## ONE MUSEUM STREET

Application for planning permission: 2023/2510/P  
Application for listed building consent: 2023/2653/L

# OBJECTION

SUBMITTED ON BEHALF OF THE SAVE MUSEUM STREET COALITION

*This development, which is twice the bulk of the existing Travelodge building, and 20m higher, will rob sunlight from all neighbouring properties to the east, north and west*

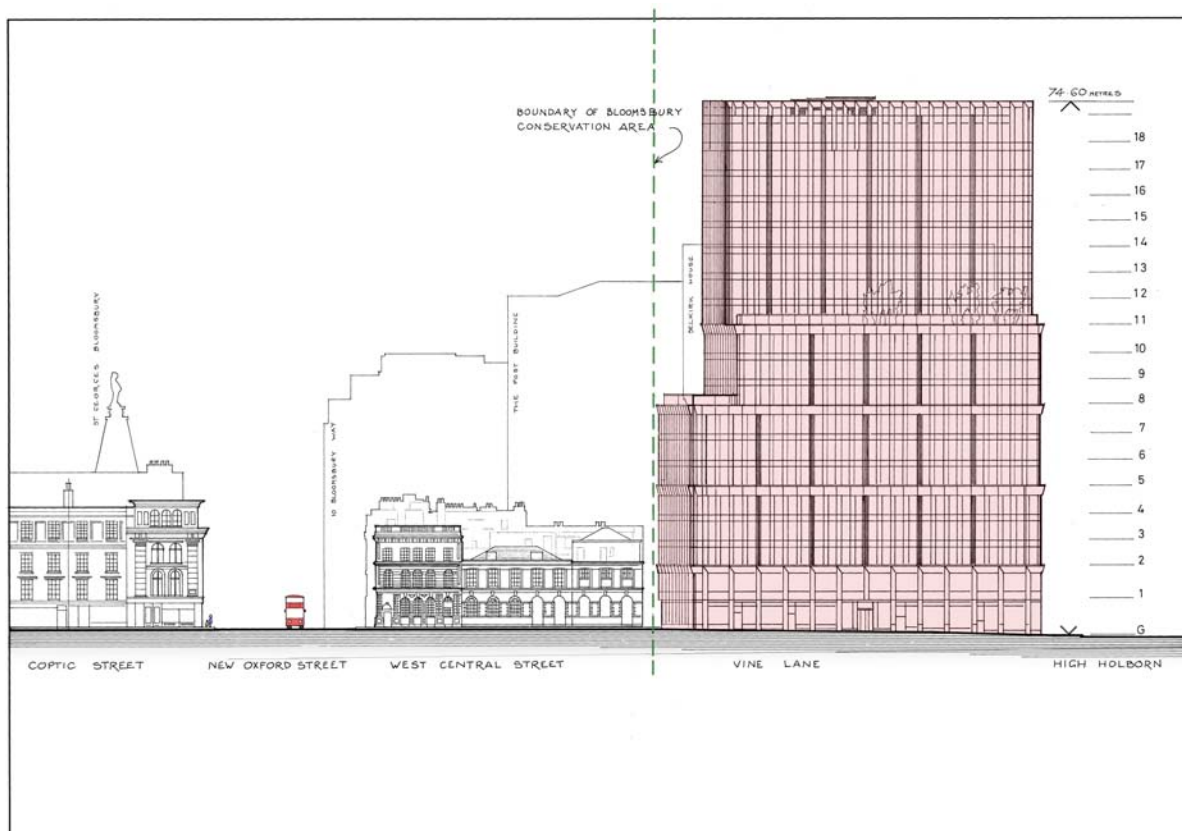
7.13 By overshadowing and blocking the daylight and sunlight onto the façades of existing neighbouring buildings this tower will be removing an existing benefit and then transferring these valuable assets to itself, all to the permanent detriment of the rest of the existing residential community. It should be remembered in this calculation that post-Covid most London office blocks are rarely open for more than about 30 hours in any one week, so this new edifice, if built, will be empty, except for a few security guards, for the remaining 138 hours (7days x 24hours = 168 hours).

*Image of developer's model of the proposed scheme*

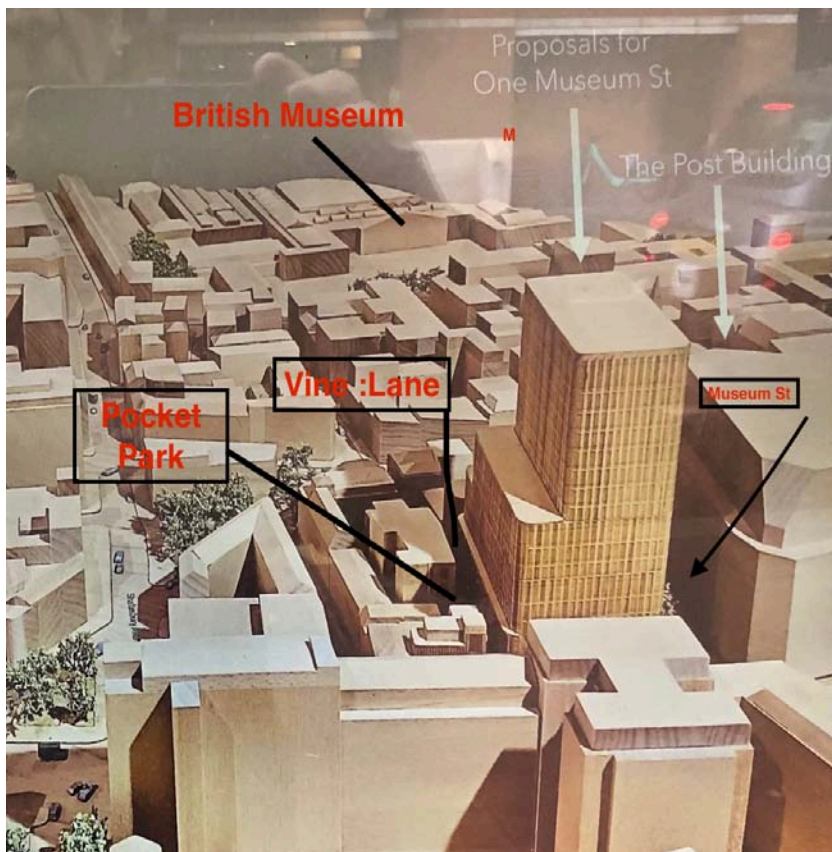
8.3.2.15 Vine Lane fails to satisfy any of these requirements; it does not integrate well with surrounding streets, as it destroys the historical street layout; it does not improve movement through the site as it connects nowhere to nowhere and certainly is not an easily recognisable north south route as it is an entirely artificial construct, unlike Museum Street, and will not contribute to the street frontage as the retail units off the alleyway are very likely to remain empty as it is a very unappealing passage with minimal footfall. The alleyway will be overwhelmed by the office tower, and the seven-storey rising to eight blocks on the west side and the proposed architecture has rightly received highly critical comments from Save as well as the Victorian Society. Vine Lane will be grim and the same applies to the minuscule pocket park off it. Rather than being a public benefit it is likely to become a considerable public nuisance. Vine Lane does not lead to a realistic destination but to a four-lane road with no safe means of crossing.

8.3.2.16 The image above is of the developer's model of their scheme. The dingy nature of Vine Lane is all too apparent and is shown to be overwhelmed by the proposed tower block adjacent, and by the residential block alongside the west side, backing onto Grape Street's existing residential accommodation. As the model shows, the daylight and sunlight penetration to both Vine Lane, the 'pocket park' and Museum Street will be miserable, and certainly the development public realm around the tower block will not be attractive and welcoming spaces.

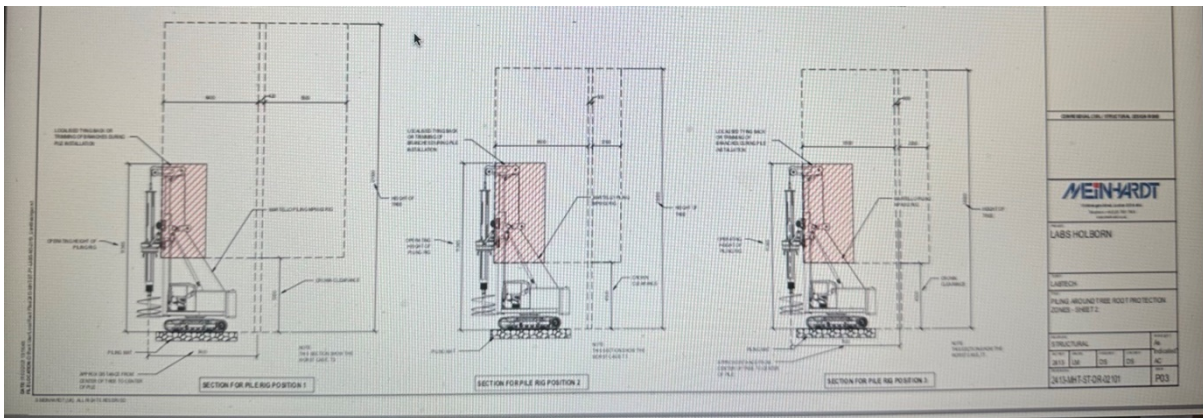
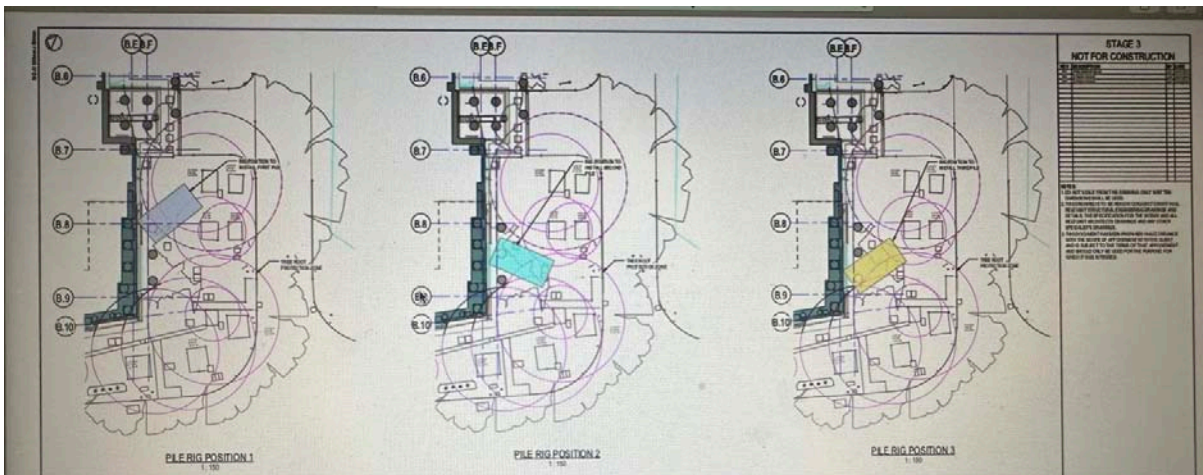
9.1.3 The deep basement proposed for the Vine Lane building requires a secant piled wall abutting the residential and commercial properties in Grape Street and will involve over two years of construction right adjacent to occupied homes. Local residents are only now recovering from the noise and disruption caused by the Post Building site; an 18-month complete office refurbishment in Grape Street; and the construction of Princes Square. They are also currently tolerating a further major refurbishment in Grape Street.

9.1.4 The BIA identifies that the proposed Vine Lane basement pile wall and underpins will create a cut-off to any existing ground water flow paths. There is more site investigation work to be done to identify whether non-static groundwater exists. Groundwater control/dewatering may be required during construction, which will add yet more noise nuisance.

Image L (image from Google Maps)

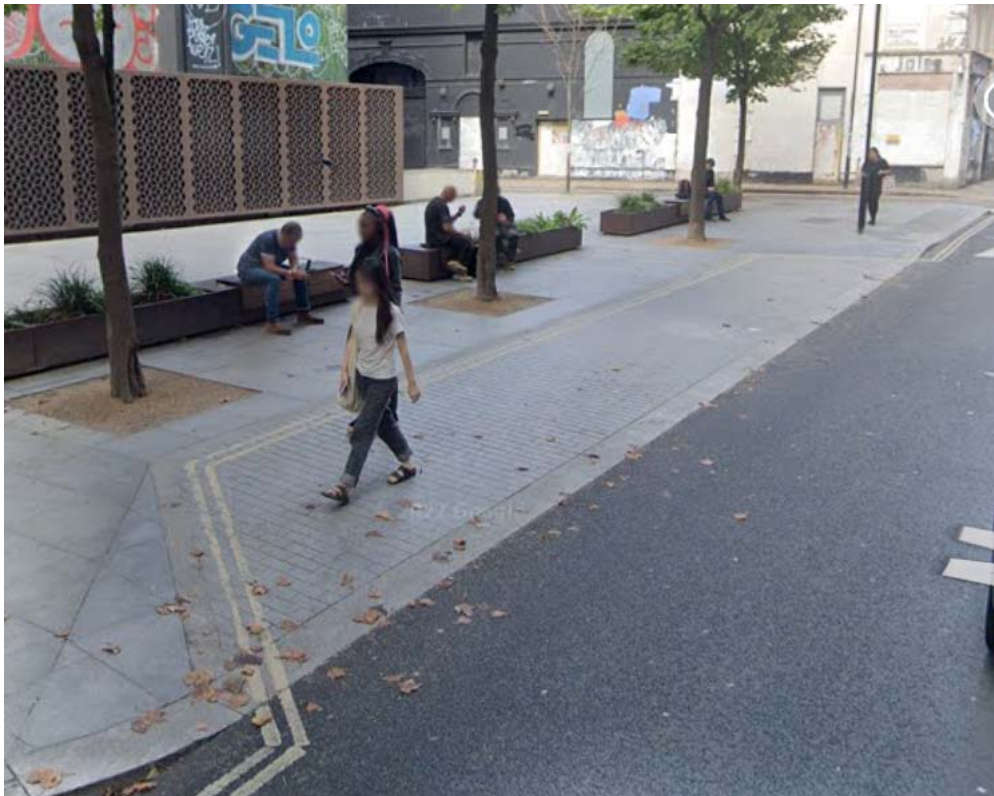
- This bay is frequently used by PHV's waiting for passengers from the Post Building and would also be used for the same purpose for passengers from the development proposed here. The occupancy of the office building is not given in the TA but the figures used to generate the trip estimate assumes that there will be 1,225 occupants at any one time. This number is likely to generate a significant number of PHV trips. The TA in fact assumes that **no-one** will arrive at or leave the building by taxi. This assumption is not supported by **any** casual observation of the usage of PHV vehicles in the West End. It appears to have been generated by assuming that all the visitors to the building will make exactly the same choice

of method of transport as those who work at the building (as suggested by the 2011 census, before app based PHV booking was available and when the number of PHV's in London was 66%<sup>4</sup> of the current figure.

Given that the DYL bay is not designated for loading and it is also used for PHV pick up, drop off and waiting it seems optimistic to assume that there is significant capacity available here.
